Access Compliance Report

Public Rights-of-Way

(Curb Ramps)

Intersection ID: 10020180	Main Street: AUBURN_AV	Cross Street: N/A	Location: S
ADA ID: DEECB3138D8C	Ramp Type: PerpDiag	Initial Pass/Fail: Fail	Overall Compliance: No
Severity Score: 22.5			
Codes/Mitigation Info/Possible Solution		Field Measurements/Component Compliance

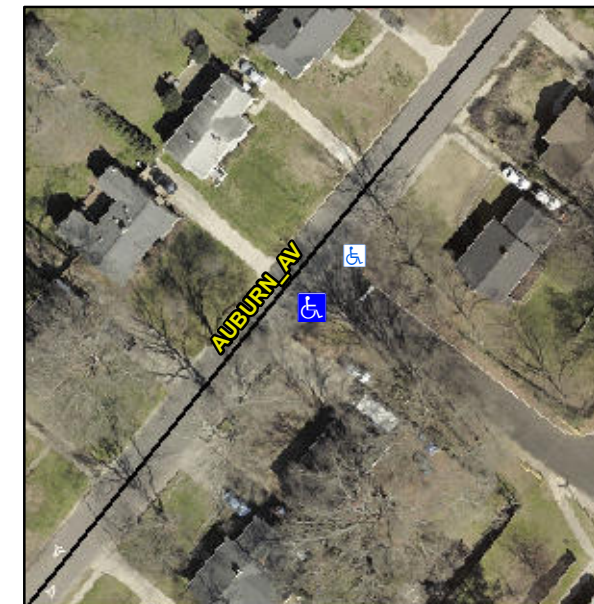
Not Found, R304.5.1, R304.2.2

Compliance	Description	Data	Compliance	Description	Data
N/A	Ramp Length (in)	34.0	No	Ramp Slope (%)	11.4
No	Ramp Width (in)	36.0	Yes	Ramp XSlope (%)	4.7
N/A	Flare Type LT	N/A	N/A	Flare Type RT	N/A
N/A	Flare Slope LT (%)	N/A	N/A	Flare Slope RT (%)	N/A
N/A	Flare Traversable LT?	N/A	N/A	Flare Traversable RT?	N/A
N/A	Landing Length (in)	N/A	N/A	DWS Provided?	N/A
N/A	Landing Width (in)	N/A	N/A	DWS Contrast?	N/A
N/A	Landing Slope (%)	N/A	N/A	DWS Length (in)	N/A
N/A	Landing X Slope (%)	N/A	N/A	DWS Full Width?	N/A
N/A	Landing Curb? (Y/N)	N/A	N/A	DWS Offset (in)	N/A
N/A	Shared Landing?	N/A			
N/A	Gutter Ponding?	N/A	N/A	Gutter Slope (%)	N/A
N/A	Gutter Lip Ht (in)	N/A	N/A	Gutter X Slope (%)	N/A
N/A	Painted X Walk1?	No	N/A	Painted X Walk2?	No
	X Walk 1 Direction	To NE		X Walk 2 Direction	To NW
N/A	X Walk 1 Width (in)	N/A	N/A	X Walk 2 Width (in)	N/A
	X Walk 1 Slope (%)	4.2		X Walk 2 Slope (%)	1.5
	X Walk 1 X Slope (%)	4.7		X Walk 2 X Slope (%)	2.2

Remove & Replace Curb Ramp With Two New Directional Ramps or Equivalent.
